Savina Technical Service Bulletin # 9

Re: Replacement of Spirolog sensor cable harness

Date: May 12, 2003

Fig.3: Spirolog sensor cable harness

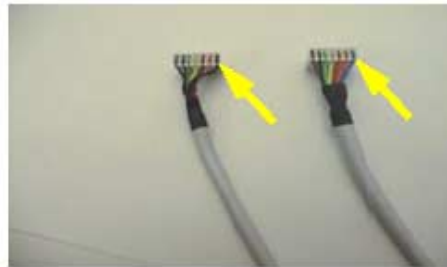
Reason: To improve the transmission of flow measurements all units with spiroplog cable harness version 1 should be upgraded to version 2.

Cable color on pin 1:

black = version 01

blue = version 02

3. If the cable harness has version 01, replace it with a version 02 cable harness.

Ordering Info: Spirolog sensor cable harness - P/N 8414028
